14. DESCRIPTION OF AMENDMENT/MODIFICATION (Organized by UCI section headings, including solicitation/contract subject matter where feasible.) Modification Control Number: jacada40121974 CONTRACT N40085-11-C-4026, BACHELOR ENLISTED QUARTERS, P-136, MARINE CORPS AIR STATION CHERRY POINT NORTH CAROLINA  REASON: CREQ AMOUNT: 0 DAYS: 0 OCD: 24 July 2013					
Except as provided herein, all terms and conditions of the document referenced in Item 9A or 10A, as heretofore changed, remains unchanged and in full force and effect.

1. The purpose of this modification is to incorporate the follow into the contract:
  - a. The contractor shall construct an off-site storm water system in accordance with the attached design documents

PROFILE 4

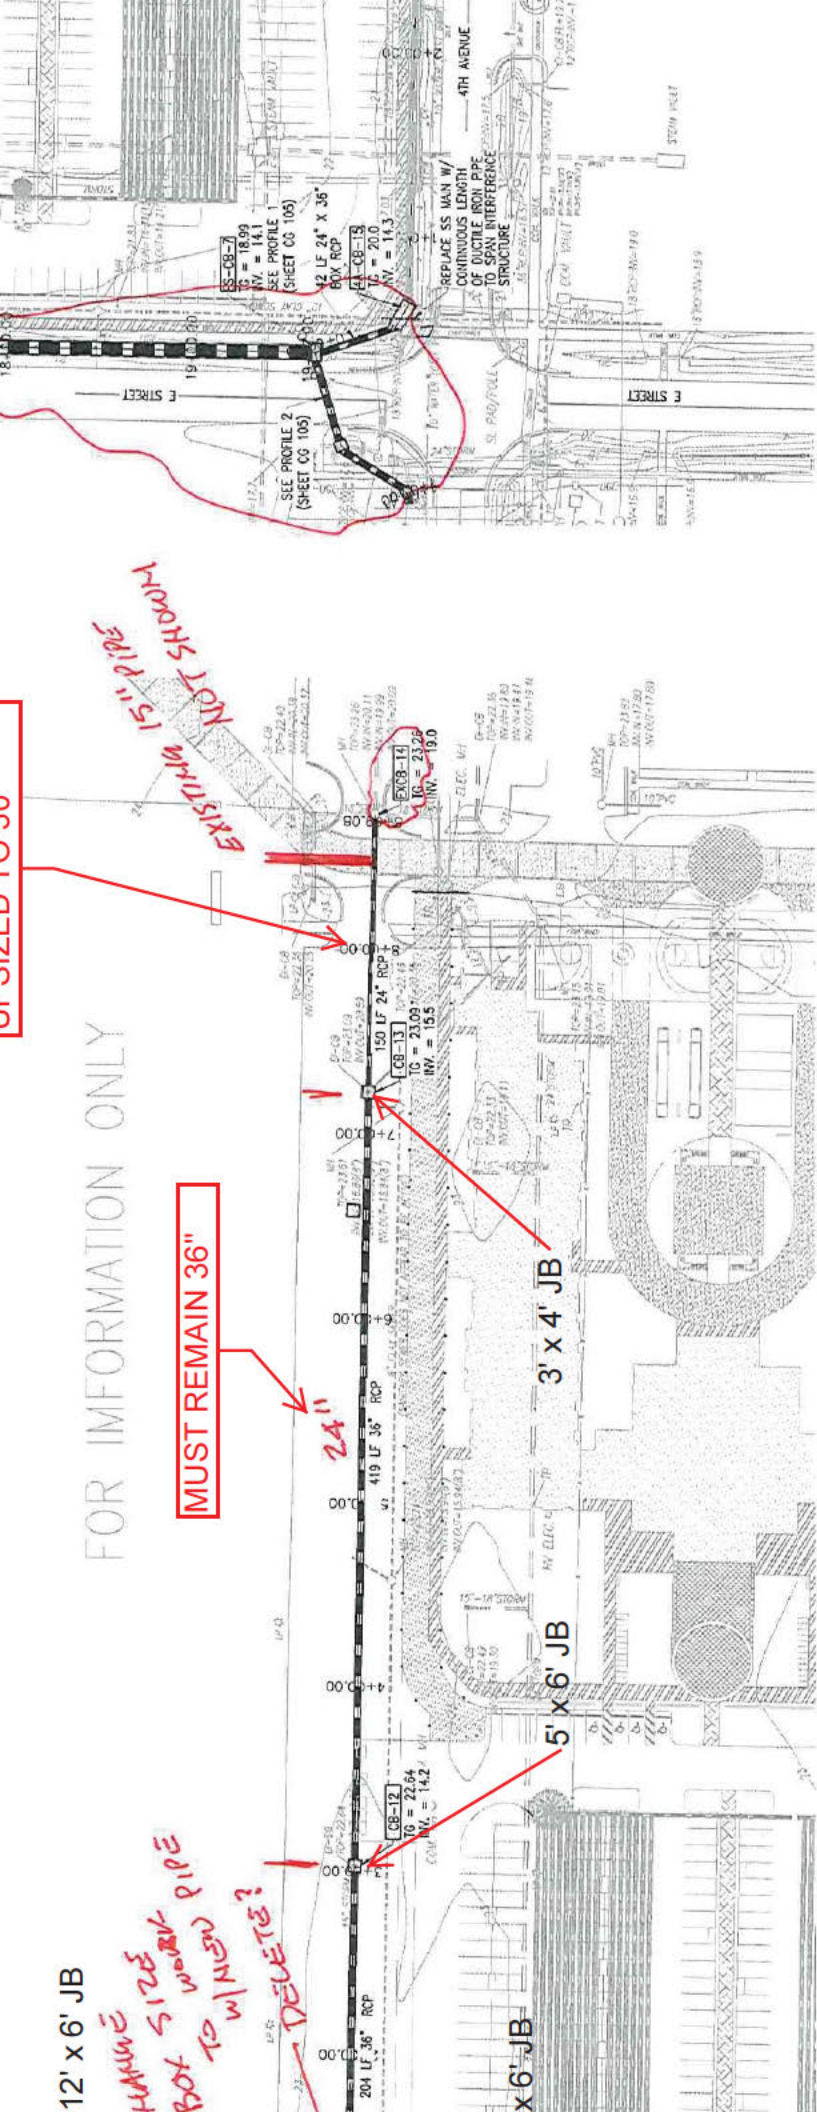
MUST REMAIN 36"

DELETE?

HAVING  
BOX SIZE  
TO WORK PIPE
